SIB 11 09 23

RECALL 23V-707: REPLACE VANOS ADJUSTMENT UNIT SCREWS

This Service Information Bulletin (Revision 8) replaces SI B11 09 23 **dated March 2025**.

Version 1 VANOS Gears (not affected)

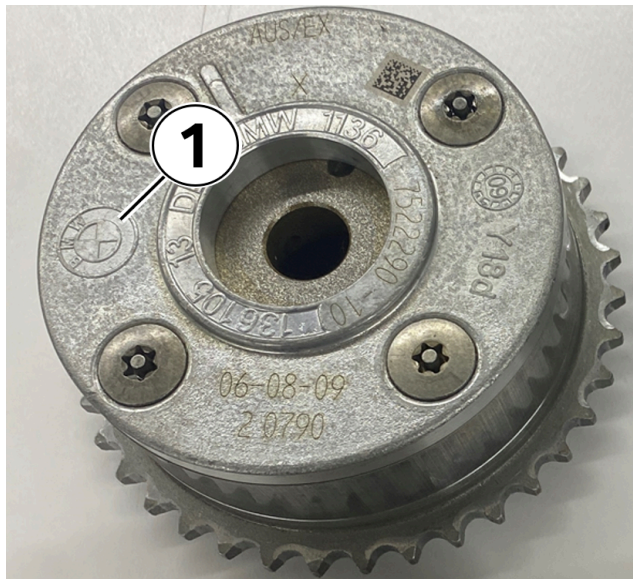
Review the Version 1 and Version 2 examples of the BMW VANOS gears provided below.

Version 1 – Is not affected by this Recall.

Version 2 – Is affected by the Recall.

Version 1 VANOS gears are not affected because the 4 assembly bolts are of a different design, and are installed in the front side of the VANOS gear as shown.

If version 1 VANOS gears are identified, then you do not need to make any further repairs.

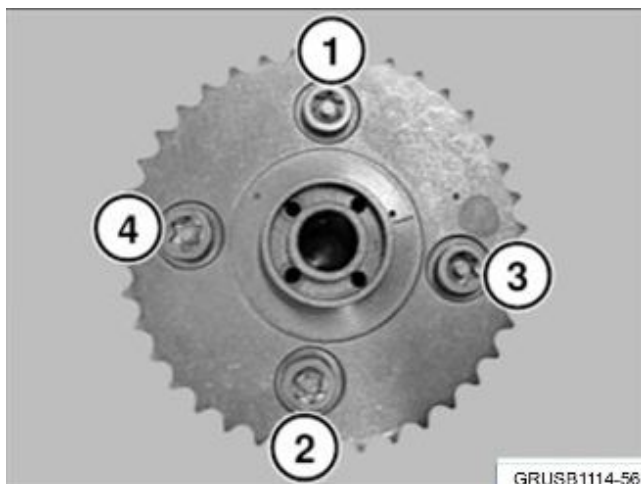
The BMW Roundel (1) is shown.

Impulse wheel installed.

To ensure it is a BMW genuine part you will need to use mirror or a borescope to look behind the impulse wheel if the BMW roundel is not already aligned with one of the segments in the impulse wheel.

Do not remove the impulse wheel.
